**Re: SECTION 4.55 (1A) MODIFICATION APPLICATION TO SSD 7751
BULLI HOSPITAL AGED CARE CENTRE OF EXCELLENCE
22 HOSPITAL ROAD BULLI**

This Modification Application has been prepared by TCG Planning on behalf of Health Infrastructure NSW, seeking consent to modify various aspects of the SSD 7751 approval at 22 Hospital Road, Bulli (the subject site) pursuant to Section 4.55(1A) of the *Environmental Planning and Assessment Act, 1979* (EP&A Act).

Figure 4: Excerpt of stamped approved Landscape Plan indicating proposed tree to be deleted in this modification shown circled in red. (Excerpt from Arcadia Landscape Architecture Ref: 16-370 Sheet 406 Issue F dated 7/6/2017) Stamped Approved Plan SSD7751 Sheet 44 of 49

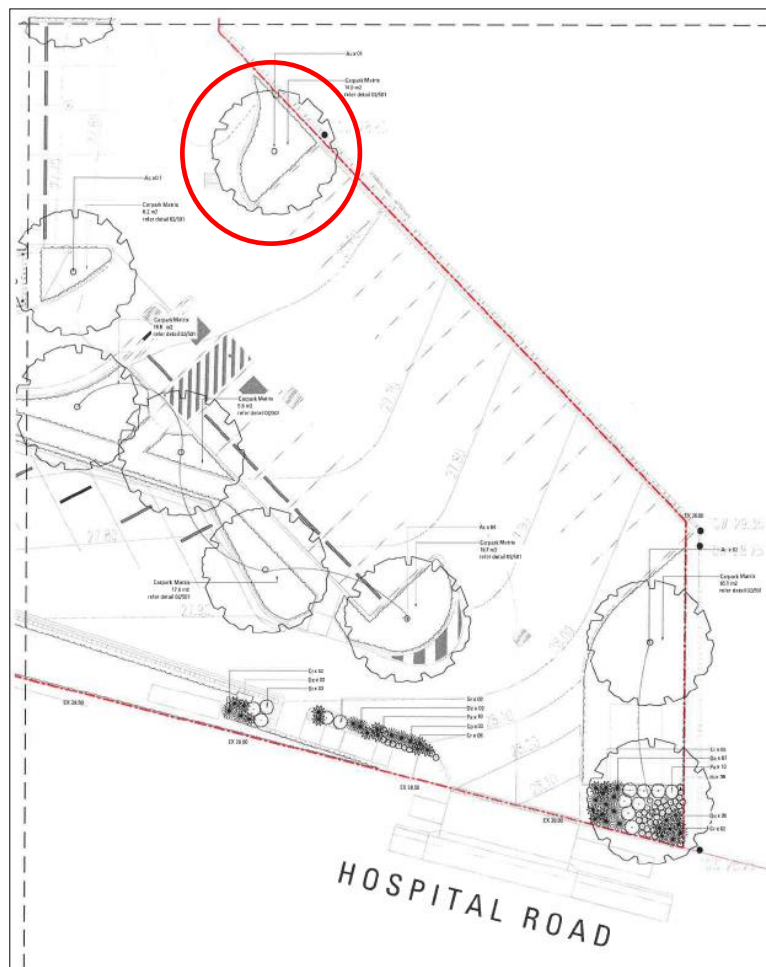
The removal of a proposed tree adjacent to car space 18 (*Angophora costata*/Smooth barked Apple as indicated on the approved Landscape Plan, refer location and detail at **Attachment 2** and **Figure 4**

below) was unavoidable as there is insufficient soil depth for large tree growth due to a structural slab being required to be constructed in this location in association with the adjacent large retaining wall (refer photograph at **Figure 3**).

It is considered that the reduction of the tree in this location can be ameliorated by planting of a smaller species suited to the shallower soil depth (which can be imposed as a condition of consent). Alternatively, a condition can be imposed requiring a planter box to be provided in this location to accommodate a larger tree similar to that originally proposed/approved.
